REVIEWER NOTES

PROPOSED IMPROVEMENT BRIDGE PROJECT

TOWN OF CHELSEA
COUNTY OF ORANGE

PRELIMINARY PLANS 7/1/2015

FILE NAME: z12c150+typ1.dgn
PROJECT LEADER: J. OLUND
DESIGNED BY: B. TOOTHAKER
TYPICAL SECTIONS AND DETAILS I

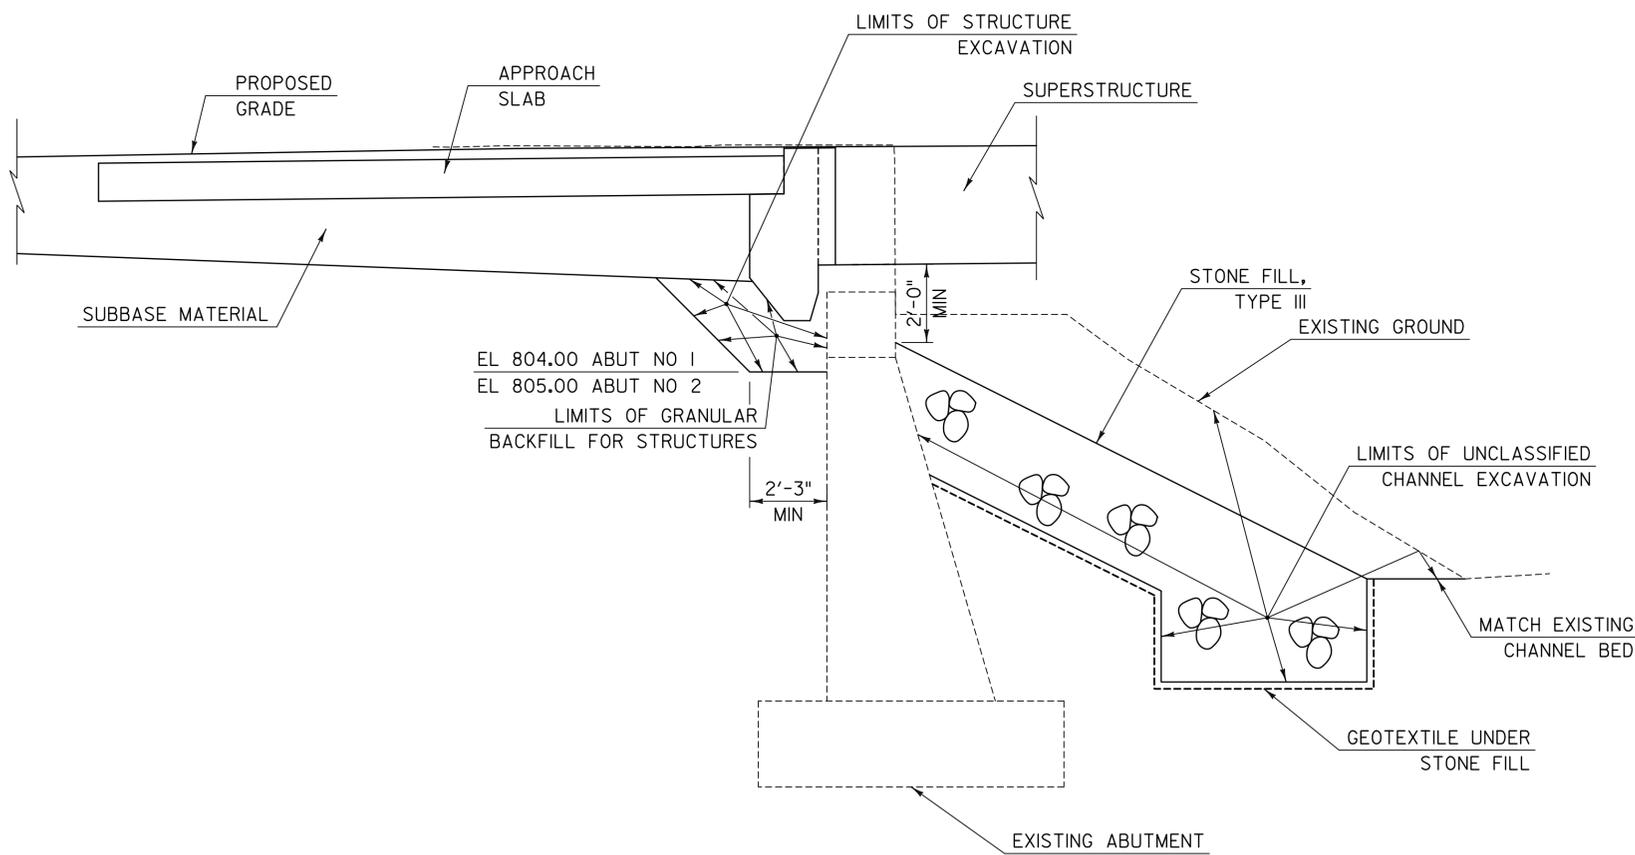
TO BE DRAFTED
FOR FINAL PLANS

PROJECT NAME:	CHelsea	PLOT DATE:	7/1/2015
PROJECT NUMBER:	BHF 0169(9)	DRAWN BY:	S. MORGAN
FILE NAME:	z12c150pe.dgn	CHECKED BY:	J. OLUND
PROJECT LEADER:	J. OLUND	SHEET	28 OF 43
DESIGNED BY:	B. TOOTHAKER		
PLAN AND ELEVATION

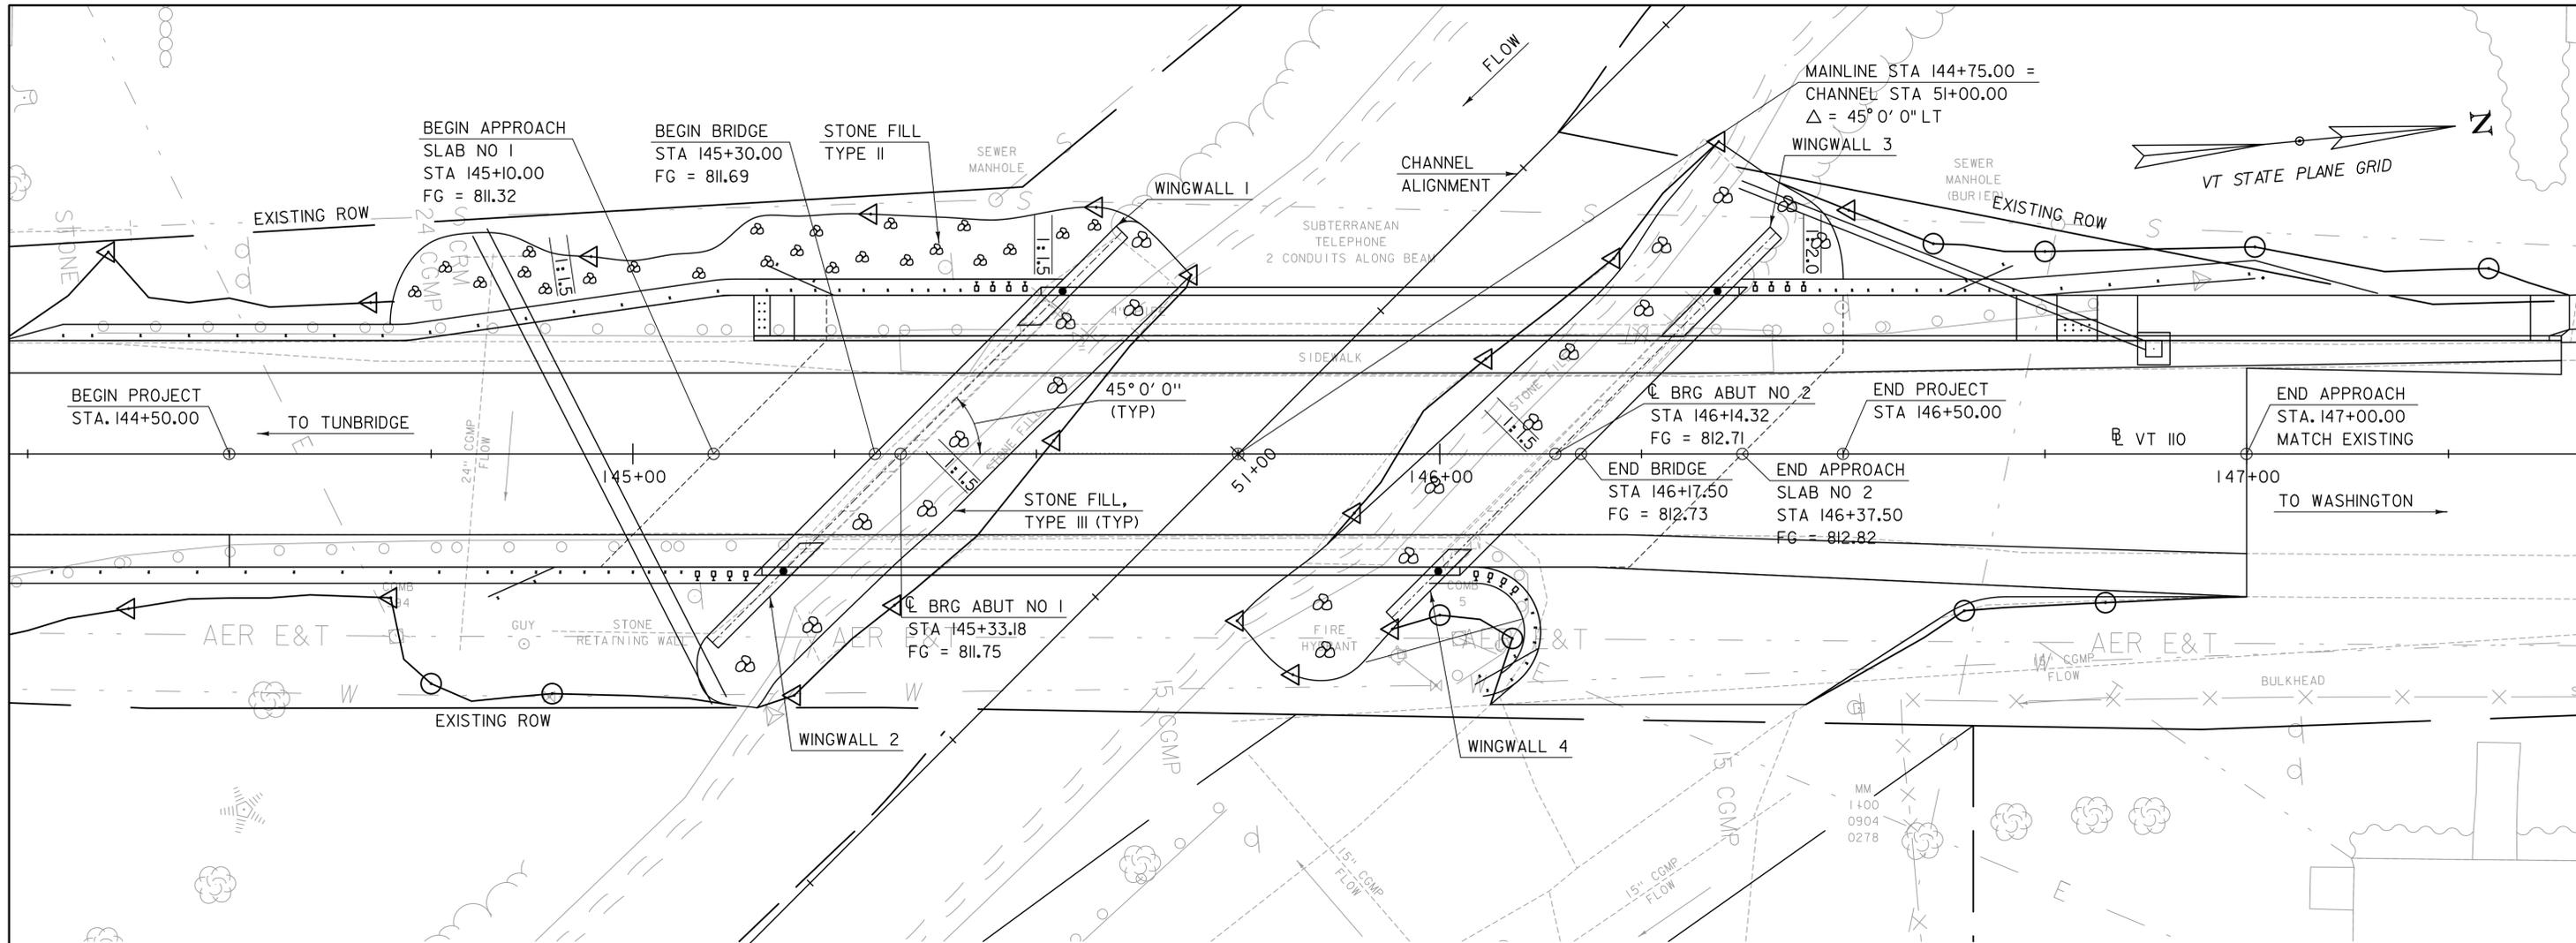
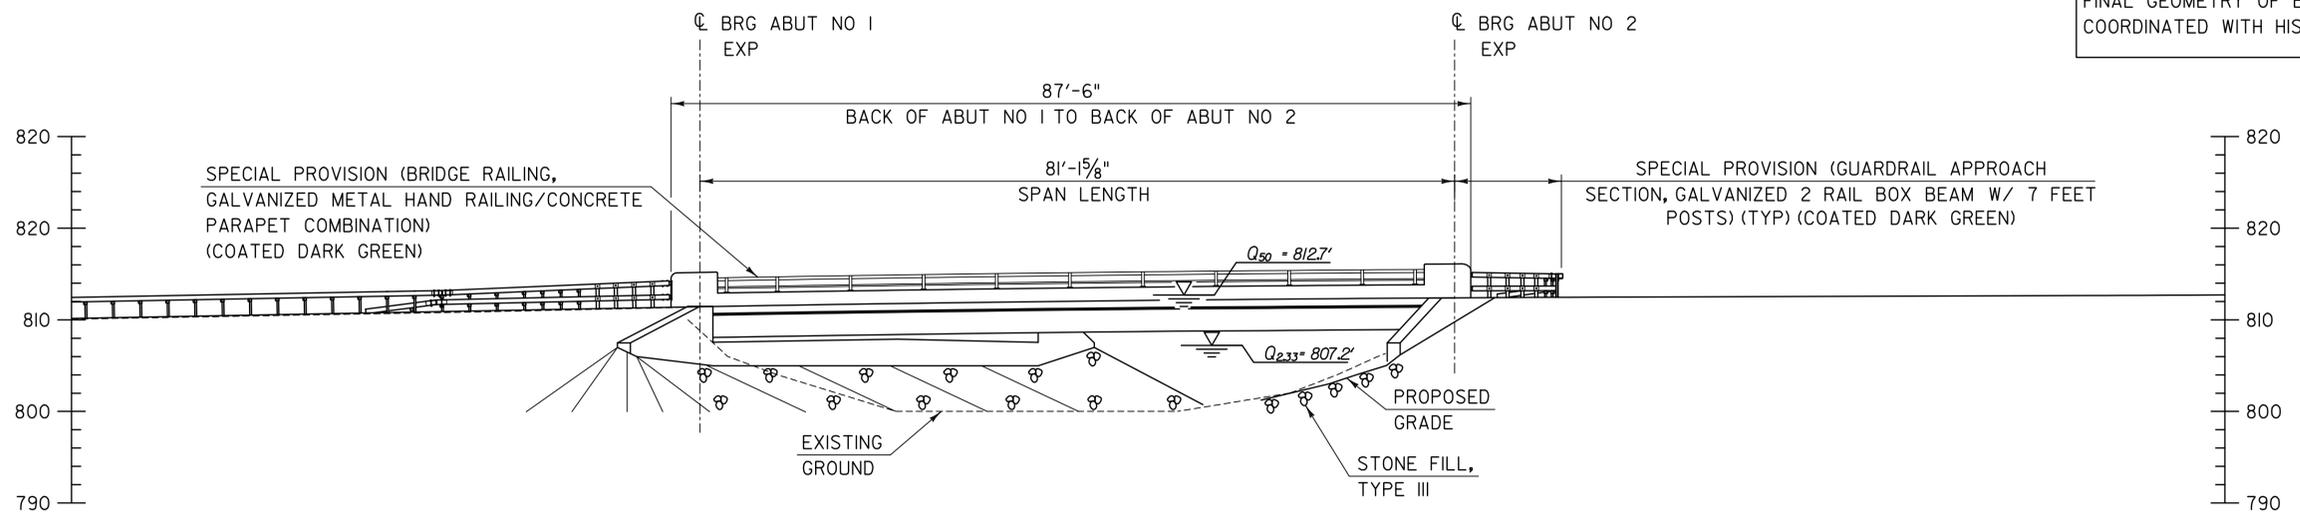
REVIEWER NOTE:
FINAL GEOMETRY OF BRIDGE RAIL TO BE COORDINATED WITH HISTORICS.
